COUNCIL MEETING

CONCEPT PLAN

Homestead Road Tri-Point

February 9, 2022

Town's Urban Designer

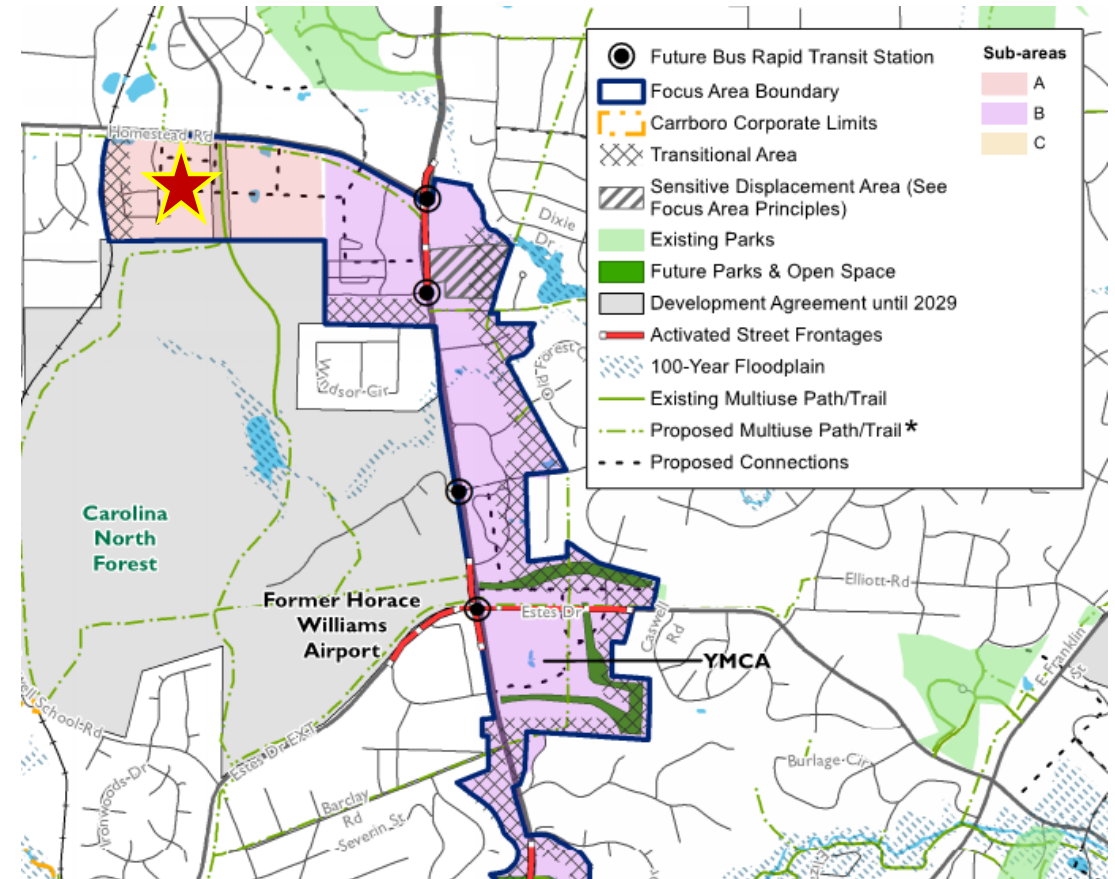
- Architectural treatment of corners – use of pergolas or other architectural details
- Consider rear loaded units
- If front loaded, minimize garage doors by recessing or other architectural element
- Emphasize on front entrances to units
- Opportunity for “Missing Middle” housing
